Addendum 1

Solicitation 21-99400

2021 Street Preservation Project

DRAWN BY:	TSM
TYPICAL SECTIONS – MATTERHORN DR	
SHEET NO.	98 OF 172

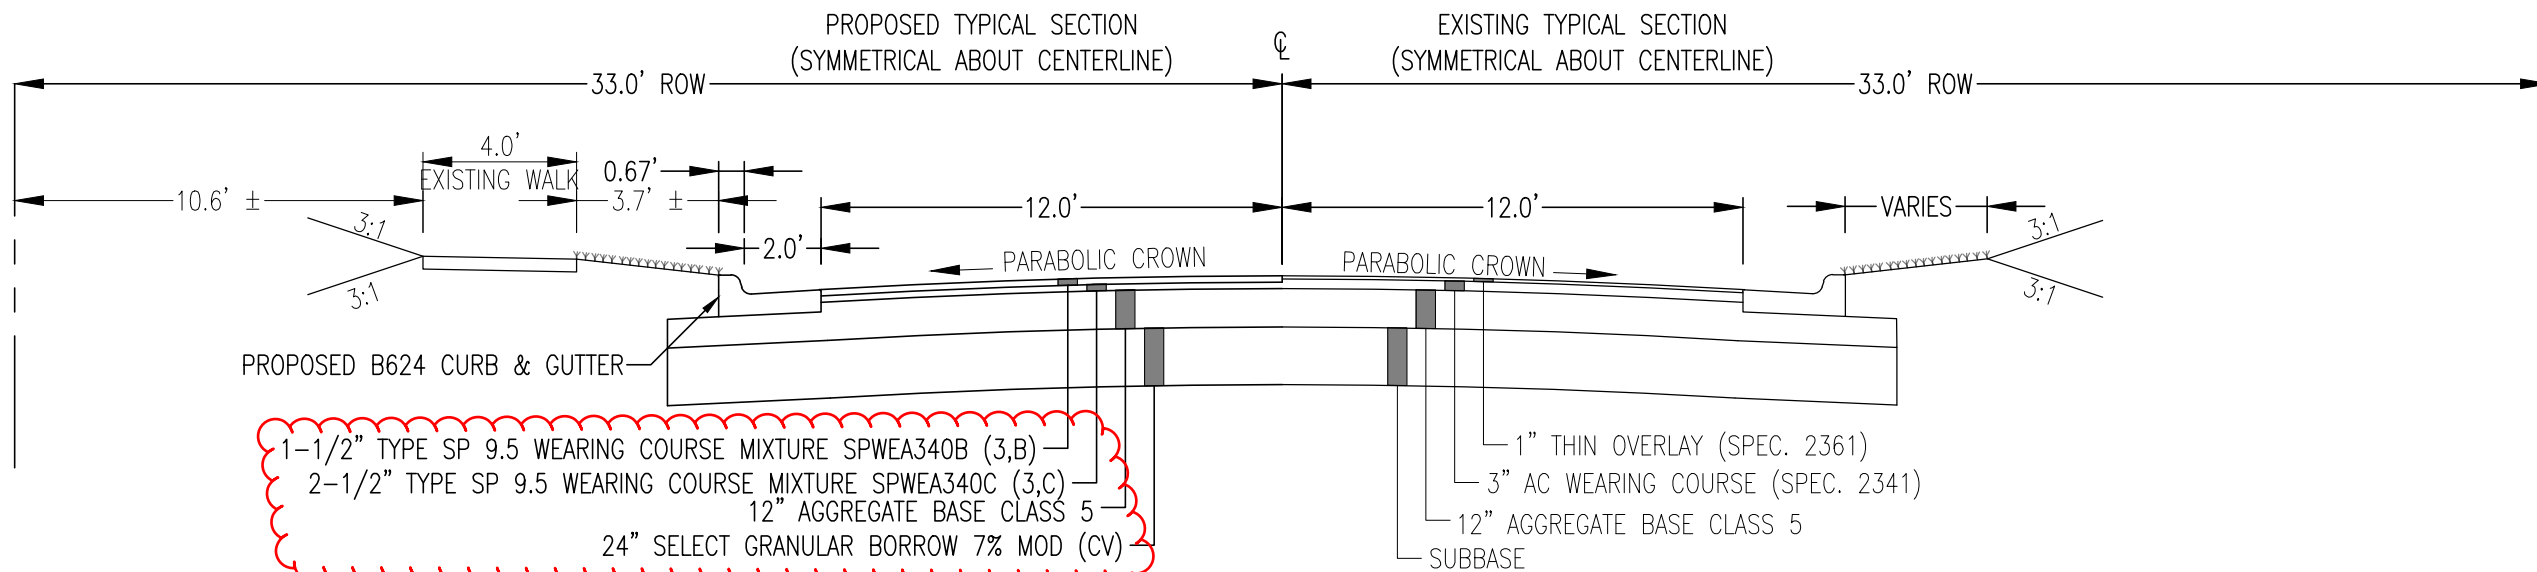
- i. Plan Sheets for Burning Tree Road, Matterhorn Drive, and Mountain Shadow Drive show placement of a non-wear course of SPNWB340C. Contractor shall use the wear course mixture of SPWEA340C on all lifts as shown in the SEQ. See attached Sheets 98, 102 and 152 for updated Typical Sections showing these changes.

TYPICAL SECTIONS - NORTON RD

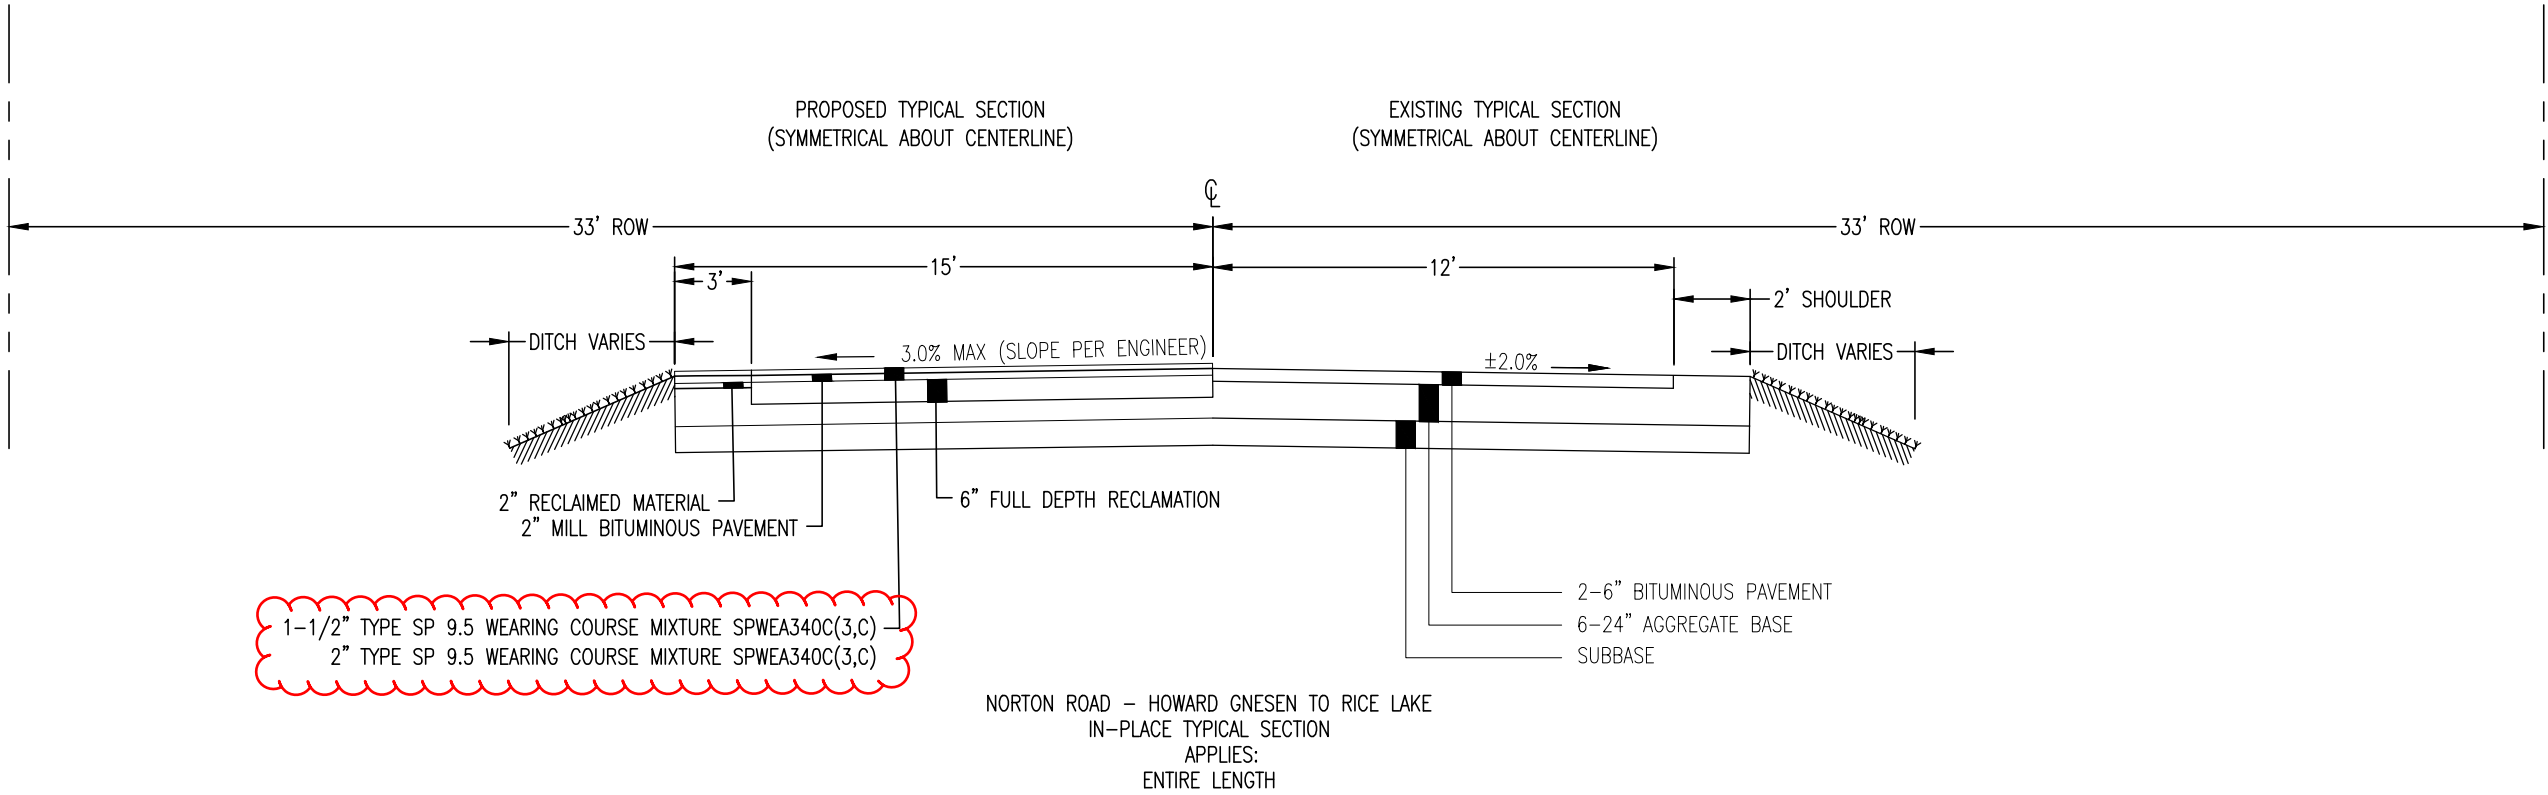
- j. Norton Road and all reclaim roadway sections shall be constructed with two lifts of SPWEA340C of bituminous pavement. See attached Sheet 127 for the updated Norton Road Typical Section.

TYPICAL SECTIONS - N LAKE AVE

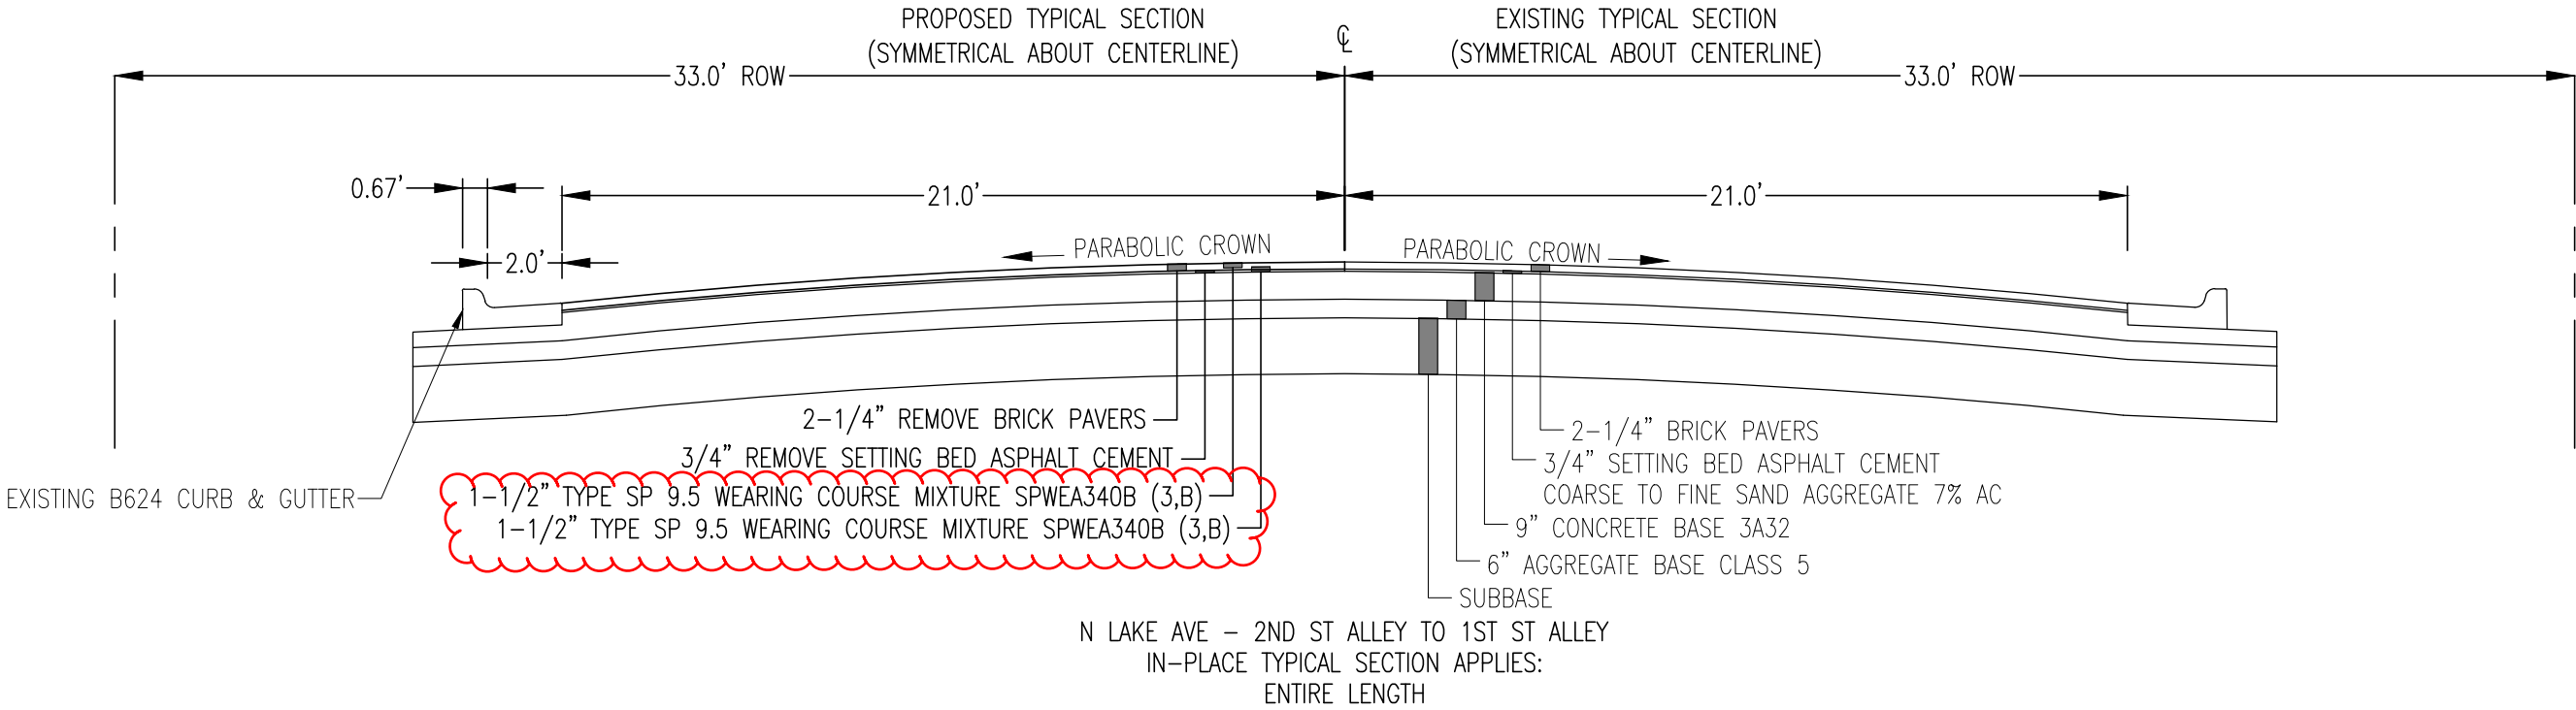
- h. Plan Sheet 145 for North Lake Avenue shows placement of a non-wearing course of SPNWB340B. Contractor shall use SPWEA340B for bituminous pavement at this location. See attachment for the updated Typical Section (Sheet 145).
